MONTGOMERY COUNTY HISTORIC PRESERVATION COMMISSION
STAFF REPORT

Address:	25 Quincy St., Chevy Chase	Meeting Date:	12/6/2017
Resource:	Contributing Resource Chevy Chase Village Historic District	Report Date:	11/29/2017
Applicant:	Bob Shorb	Public Notice:	11/22/2017
Review:	HAWP	Tax Credit:	N/A
Case Number:	35/13-1700	Staff:	Michael Kyne
PROPOSAL: Windows, fencing, hardscape and landscape

PROPOSED CONDITIONS

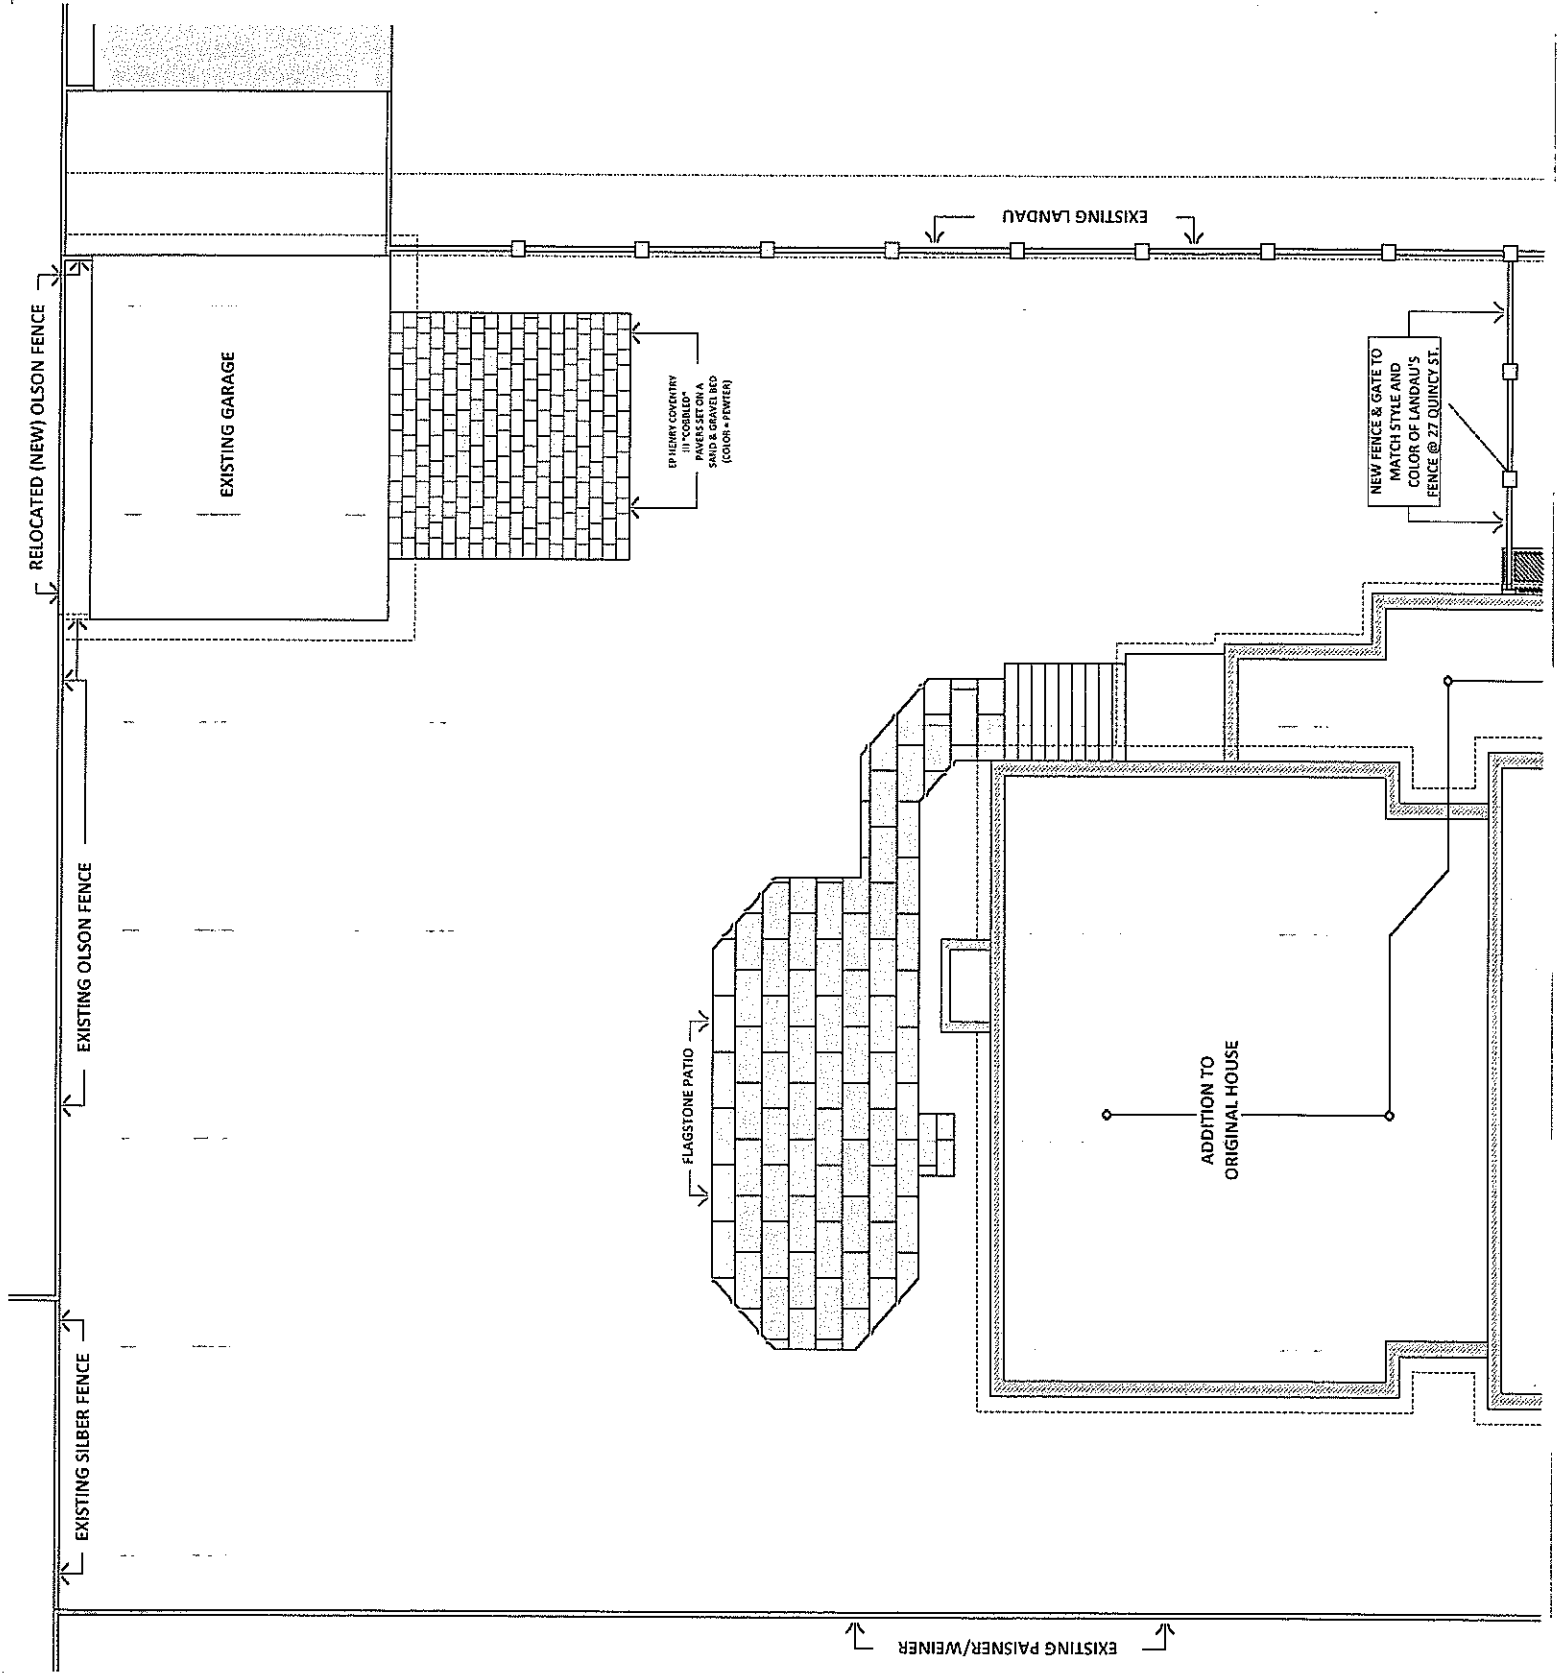
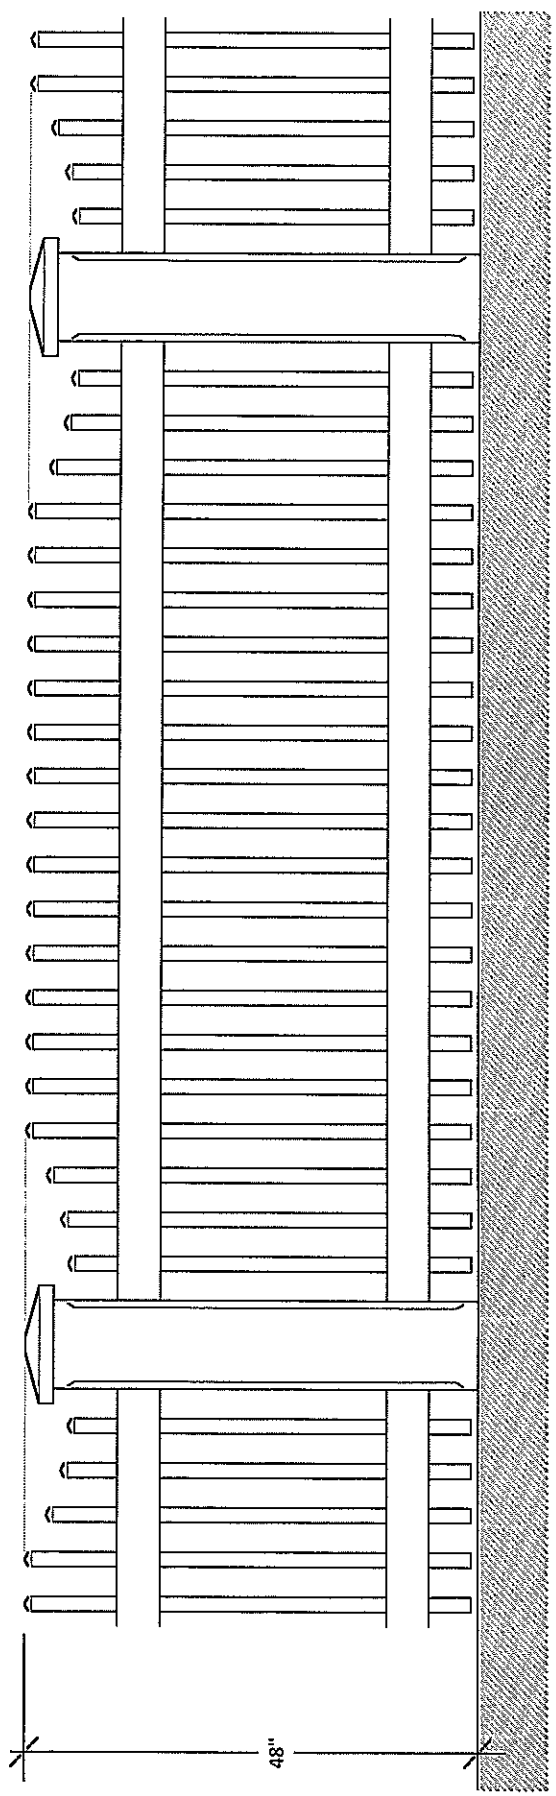
Typically, the Commission requires fences forward of the rear plane of a historic house to be no higher than 48" with an open picket design, preserving the openness of the streetscape and visibility of the historic house. While the proposed fence alterations are generally consistent with the Commission's requirements, the proposed fence/gate at front corner/left side of the historic house is not, as it proposed to be a 6' tall stockade fence. Staff suggests that the Commission approve the proposed fence alterations, with the condition that the proposed fence/gate at the front corner/left side of the historic house be reduced to 48" in height with an open picket design, or the proposed fence/gate will be relocated to rear corner/left side of the historic house.

The proposed driveway will utilize an existing concrete apron and will be shifted to be entirely on the 25 Quincy Street property. The driveway will extend straight back from the sidewalk to the approximate location of an existing screened porch at the front/right side of the house. No trees are proposed to be removed to accommodate the new driveway. Staff finds the proposed driveway dimensions, location, and materials compatible with the surrounding streetscape.

1. The proposed fence/gate at the front corner/left side of the historic house will be reduced to 48" in height with an open picket design, or the proposed fence/gate will be relocated to rear corner/left side of the historic house.
2. The proposed new windows will have 7/8" profile permanently-affixed muntins with spacer bars.

WINDOWS PROPOSED FOR REPLACEMENT

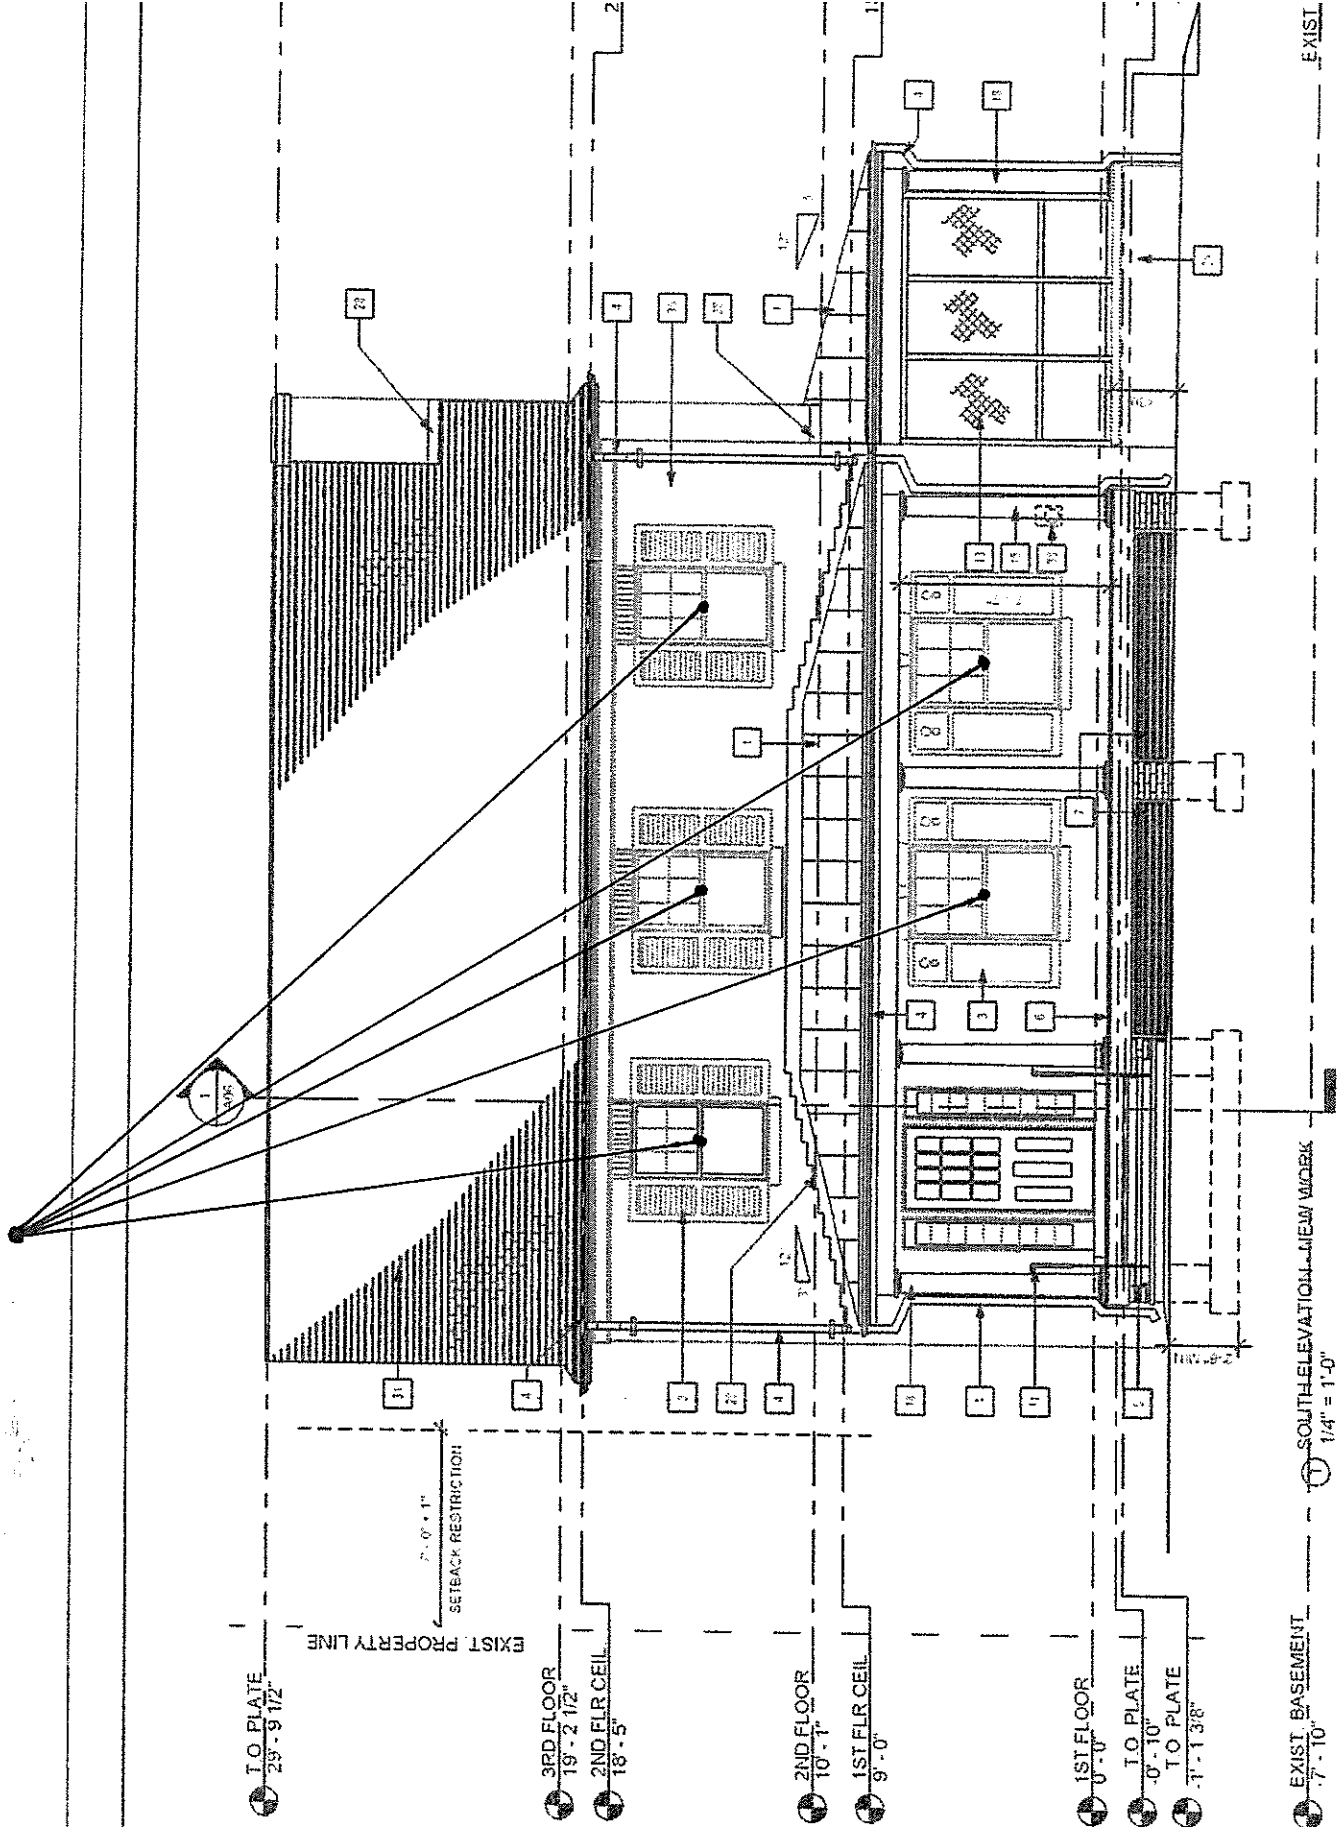
The applicant proposes to replace the five original 6-over-1 wood windows at the front of the historic house with new 6-over-1 SDL aluminum-clad wood windows. According to the *Guidelines*, the replacement of windows at non-contributing resources should be reviewed with moderate scrutiny.

Although staff and the HPC are typically opposed to the alteration or removal of original features on the primary façade of historic structures, staff notes that the subject property has experienced alterations throughout the years, including a c. 1980 renovation that resulted in the replacement of many of the original windows on the secondary elevations of the historic house.

Because the primary façade of the historic house has been significantly altered and no longer retains historic integrity, staff recommends that the Commission approve the proposed window replacement, with the condition that the proposed new windows will have 7/8" profile permanently-affixed muntins with spacer bars.
